APPLICATION NO.	FILING DATE	FIRST NAMED INVENTOR	ATTORNEY DOCKET NO.	CONFIRMATION NO.
10/527,104	03/10/2005	Melanie John	6355	3785

Office Action Summary	Application No. 10/527,104	Applicant(s) JOHN ET AL.	
	Examiner Nahid Amiri	Art Unit 3679

DETAILED ACTION

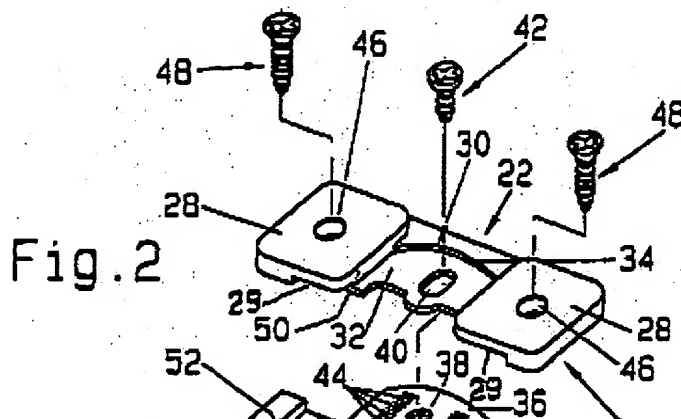
Claims 13-20 and 23-24 are rejected under 35 U.S.C. 102(b) as being anticipated by US Patent No. 5,664,288 Lautenschlager et al.

With respect to claim 13, Lautenschlager et al. disclose a connecting element (22, Fig. 2, see below) for detachably connecting several articles with one another, the connecting element (2) comprising a center part (32); a first lateral end area (28) and a second lateral end area (28); a first bent area (50) connecting the first lateral end (28) area to the center part (32) and a second bent area (50) connecting the second lateral end area (28) to the center part (32); wherein the first and second end areas (28) are positioned within a common first plane and wherein the center part (32) is positioned in a second plane; wherein the first plane and the second plane are parallel to one another and are spaced at a spacing from one another; wherein the spacing between the first and second planes is defined by a height of the first and second bent areas, respectively; and wherein the connecting element (22) has two lateral openings (46) and a central cutout (40).

With respect to claims 15 and 16, Lautenschlager et al. disclose that the first and second lateral areas (28) each have one of the two lateral openings (46); wherein the first and second

bent areas (50) are identical and that there is a mirror-symmetrical configuration relative to a central plane extending through the center part (32).

With respect to claims 23 and 24, Lautenschlager et al. disclose (Fig. 2; column 6, lines 20-21) that connecting element (22) is comprised of angled sheet metal; and wherein the first and second lateral end areas (28) have attachment points.

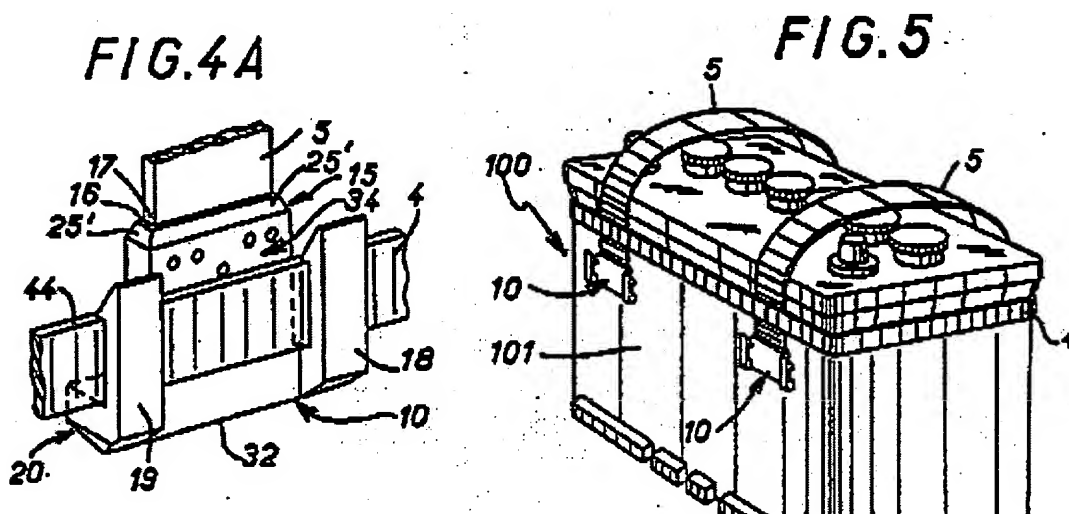
Claims 13, 15, 16, and 24 are rejected under 35 U.S.C. 102(a) as being anticipated by Pub. No. FR 2646406 A1 Gille et al.

With respect to claim 13, Gille et al. disclose a connecting element (10, Fig. 4A, see below) for detachably connecting several articles with one another, the connecting element (10) comprising a center part (32); a first lateral end area (18) and a second lateral end area (19); a first bent area connecting the first lateral end (18) area to the center part (32) and a second bent area connecting the second lateral end area (19) to the center part (32); wherein the first and

second end areas (18, 19) are positioned within a common first plane and wherein the center part (32) is positioned in a second plane; wherein the first plane and the second plane are parallel to one another and are spaced at a spacing from one another; wherein the spacing between the first and second planes is defined by a height of the first and second bent areas, respectively; and wherein the connecting element (10) has a central cutout.

With respect to claims 15 and 16, Gille et al. disclose (Fig. 4A) that the first and second bent areas are identical; and further the first and second bend areas having a mirror-symmetrical configuration relative to a central plane extending through the center part (32).

With respect to claim 24, Gille et al. disclose (Fig. 5, see above) that the first and second lateral end areas (18, 19) have attachment points.
